Texas Department of Transportation

MINOR DESIGN UPDATES UNDER CONSIDERATION FOR FINAL DESIGN

UNIVERSITY DRIVE & FUTURE US 380 INTERCHANGE

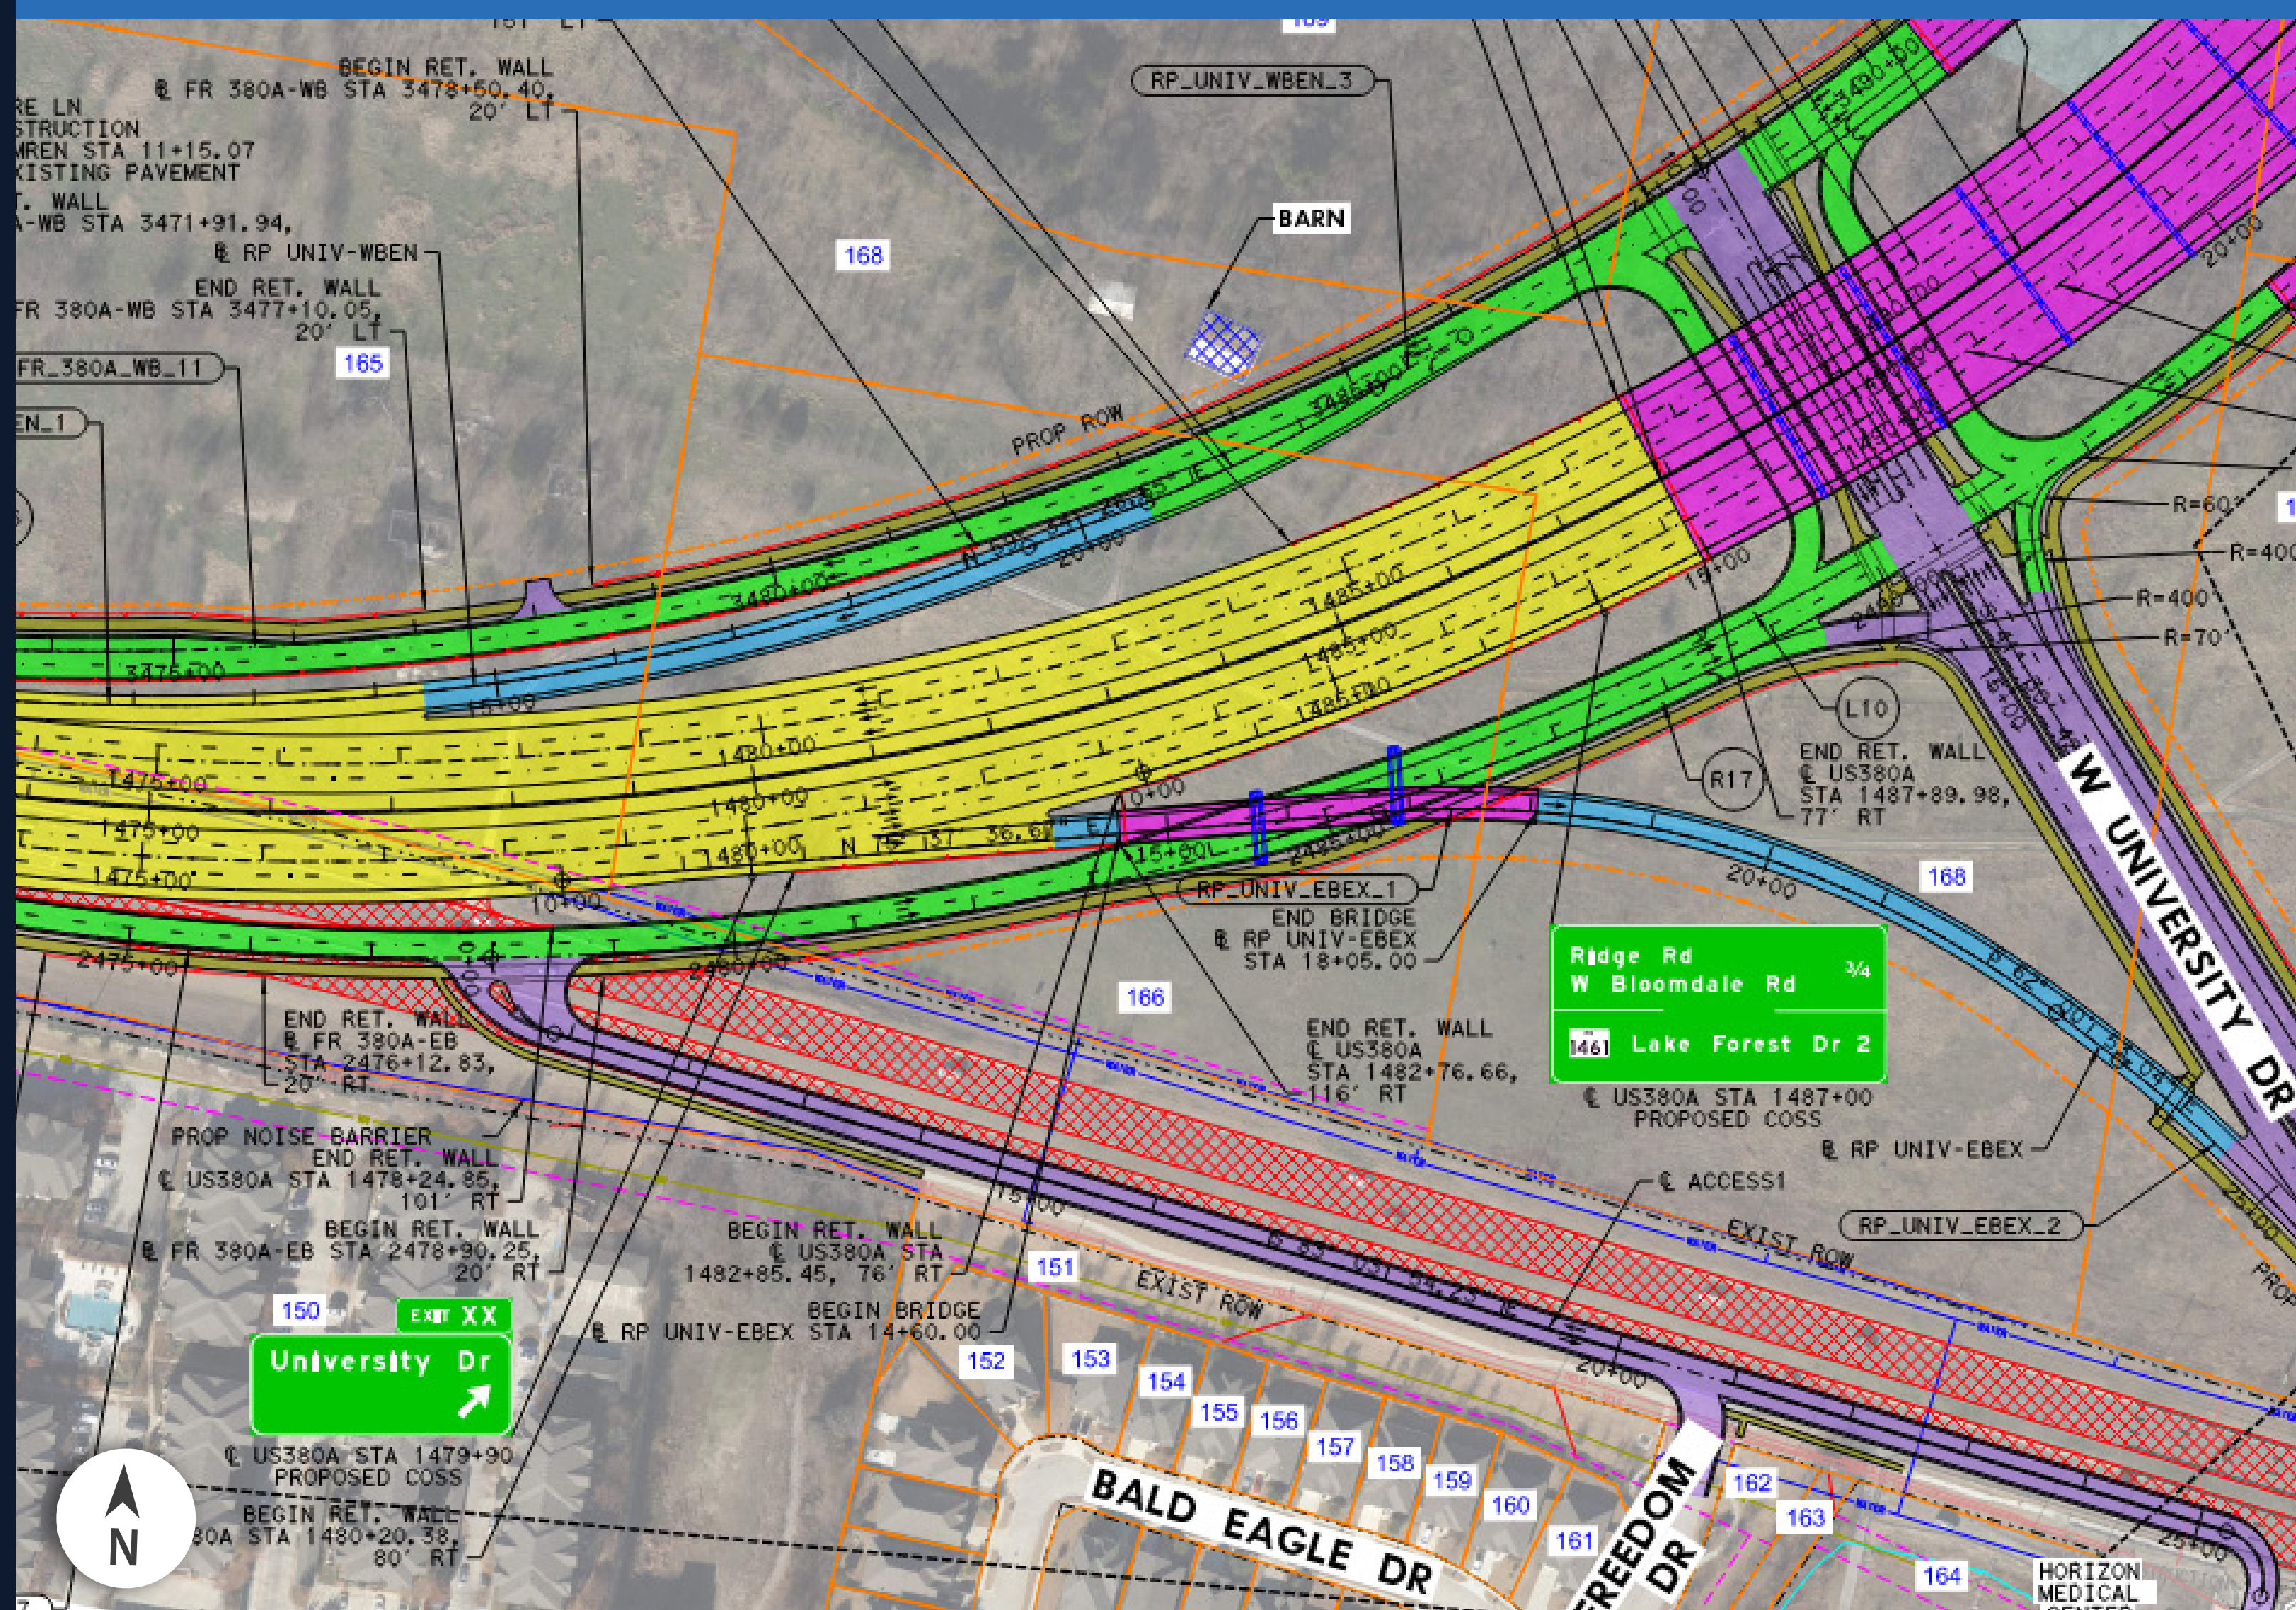
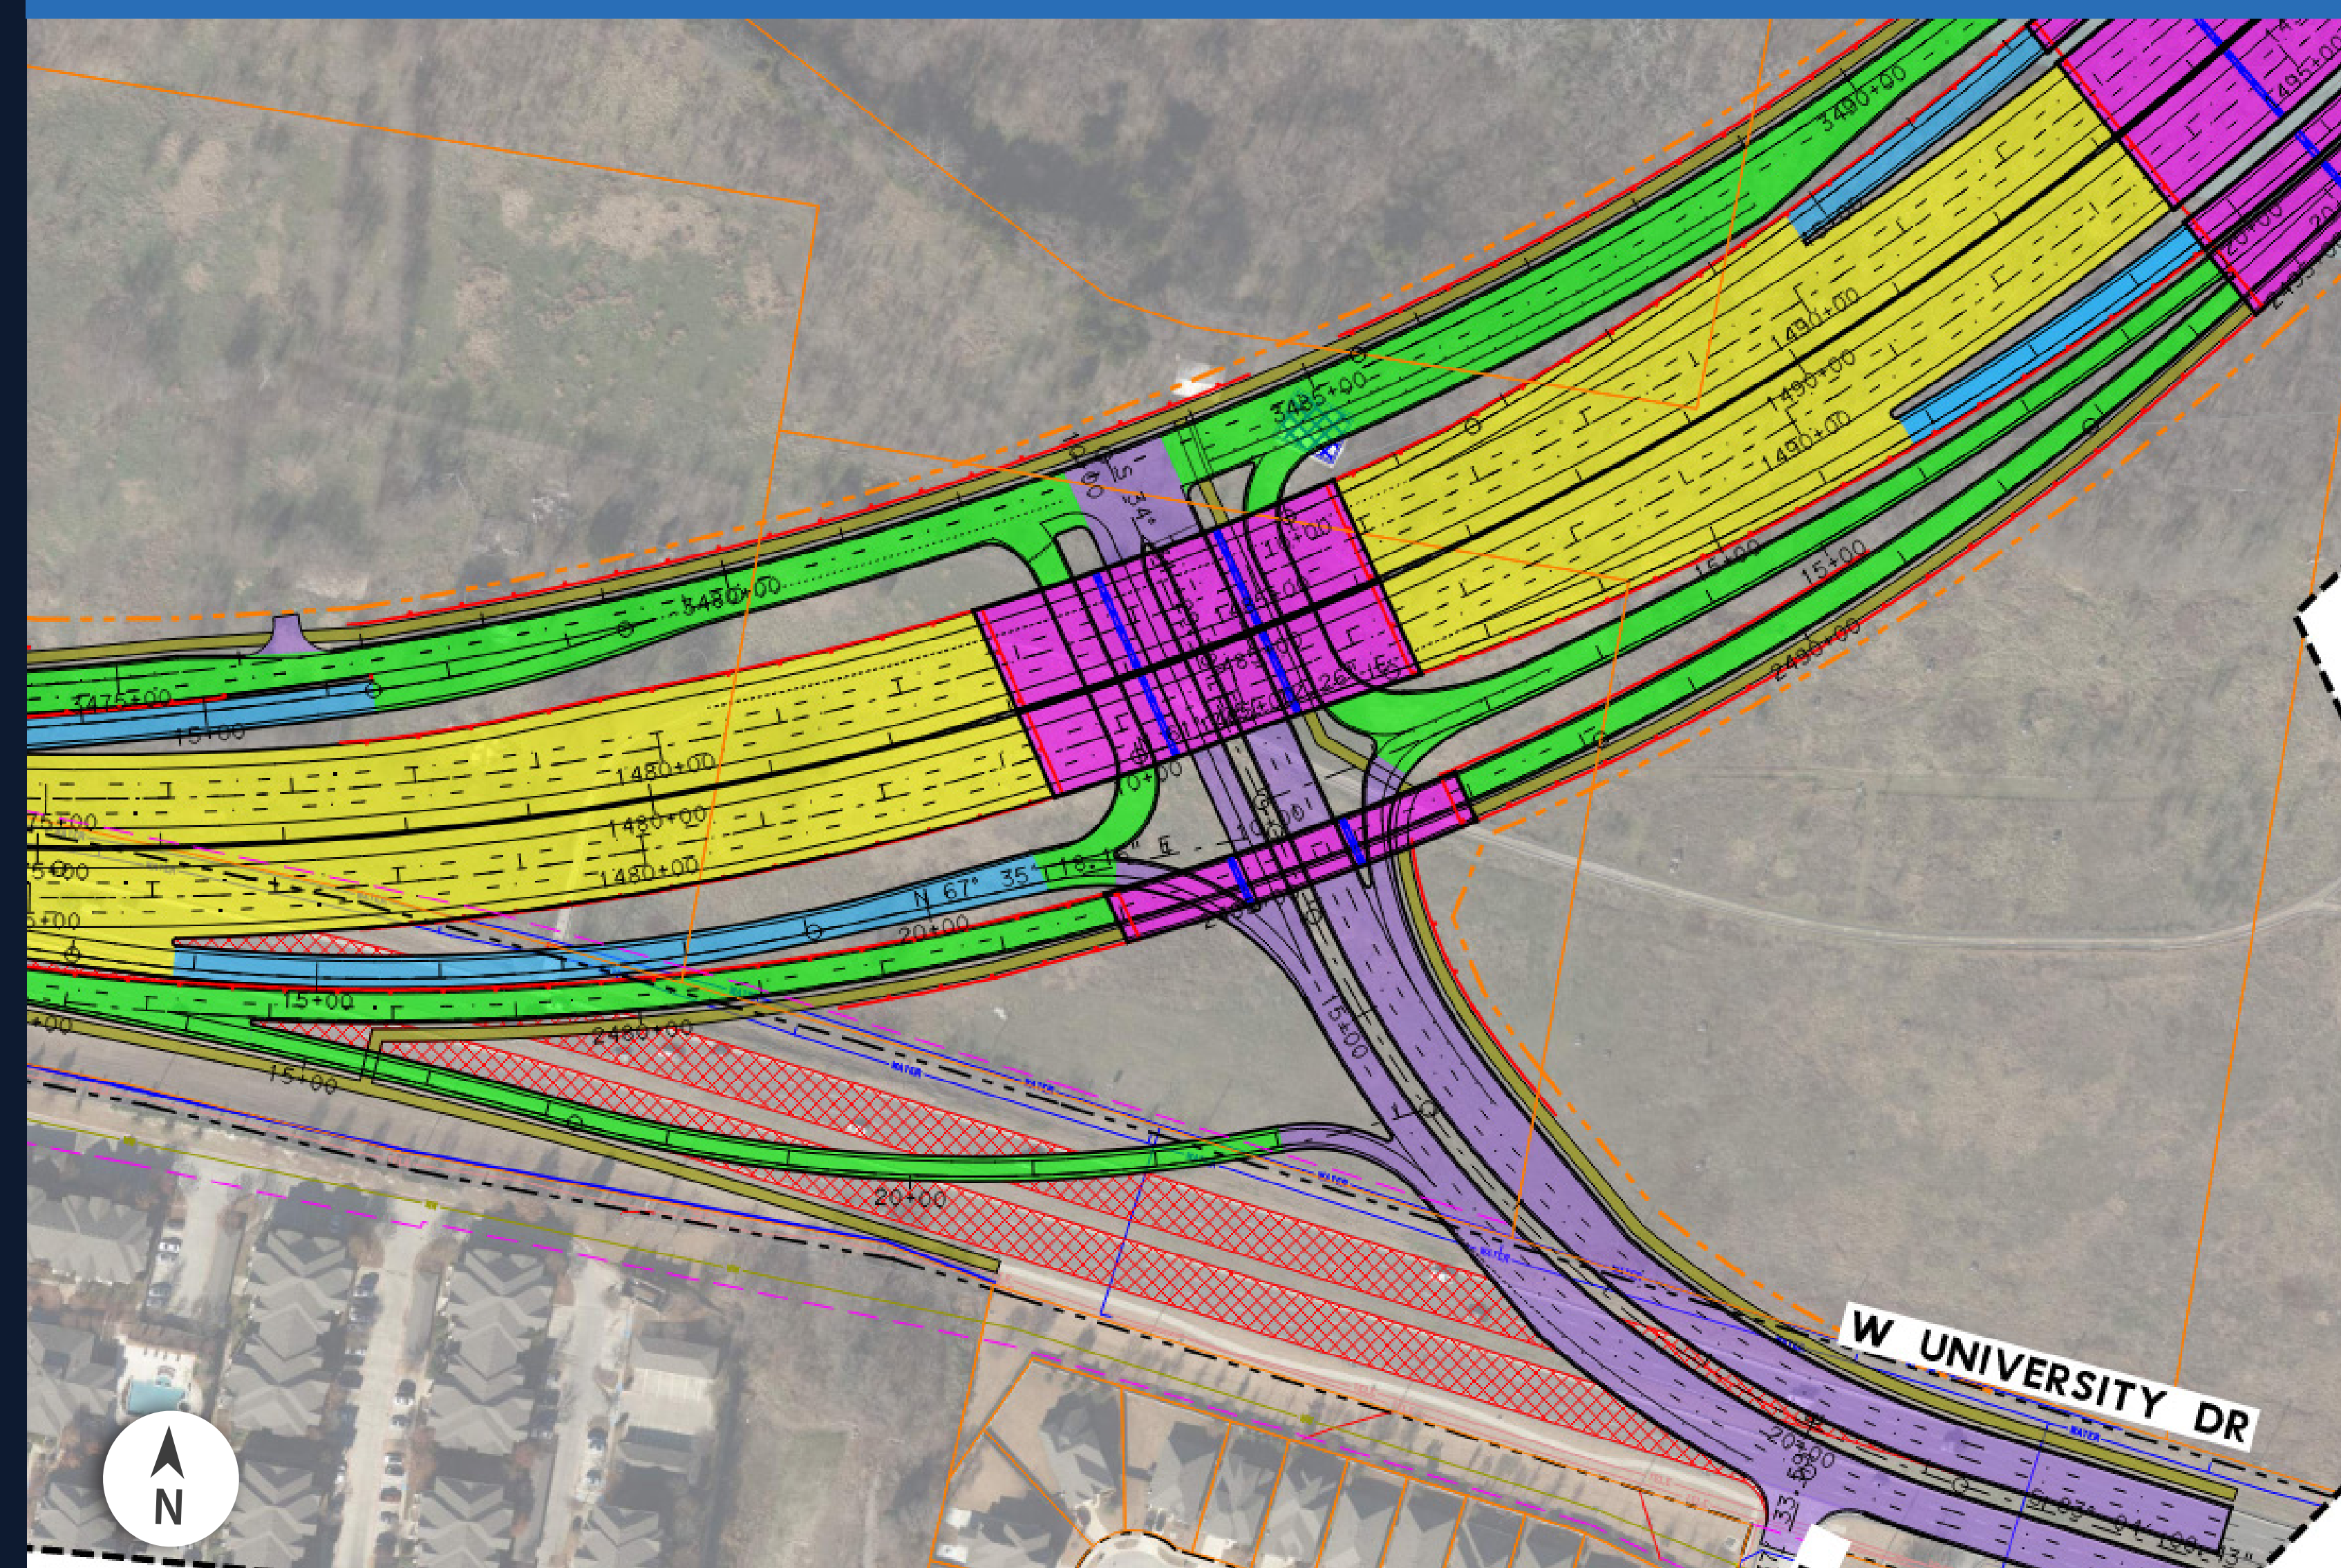
The interchange was moved southwest to minimize impacts to future developments.

A westbound entrance ramp from Wilmeth Road was also added.
